03 NEW CURB RAMP
SCALE: 1/8"=1'-0"

PAVING TYPICAL SECTIONS

ADDISON CIRCLE

PHASE II PUBLIC INFRASTRUCTURE

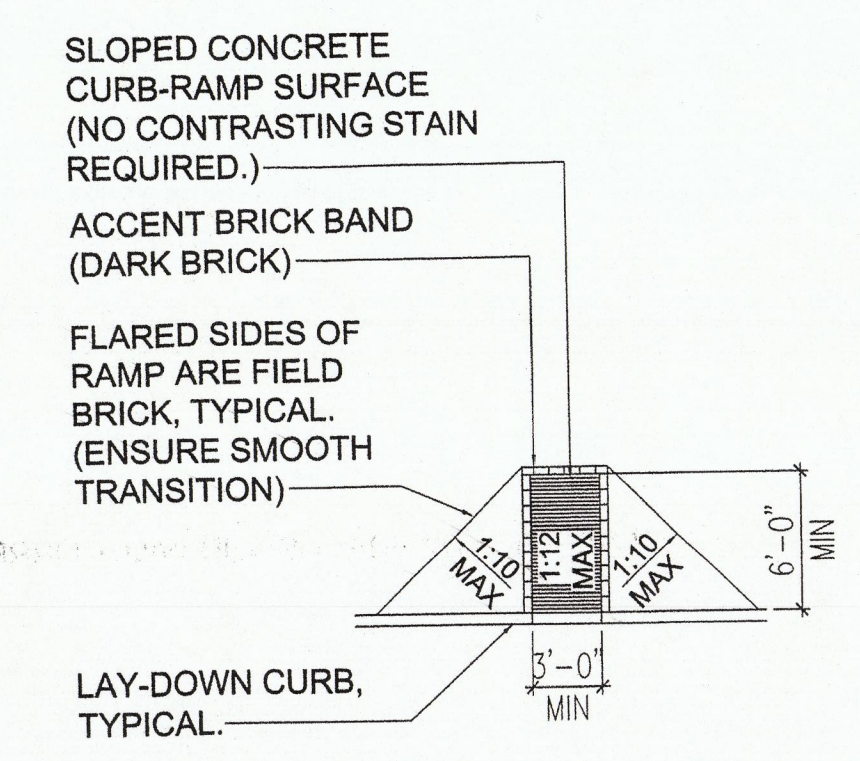
- MAXIMUM SLOPE AND CROSS-SLOPE OF HANDICAPPED ACCESSIBLE PARKING SPACES AND ADJACENT ACCESS ISLE IS 1:50 (2%) IN ANY DIRECTION.
- ALL NEW CONCRETE SHALL BE DOWNELED INTO EXISTING CONCRETE @ 12" O.C. WITH 18" ~~WIDE FORMED BARS~~ ^{#5 smooth dowels spaced @ 9" into existing perimeter concrete & face of concrete.} ALL NEW SIDEWALK/CONCRETE SHALL BE CONSTRUCTED OF 4" THICK 4000 PSI CONCRETE WITH NO. 3 BARS @ 12" O.C. OVER 1" SAND BEDDING COURSE. ENSURE 2" CONCRETE COVERAGE ON ALL STEEL BARS, TYPICAL.
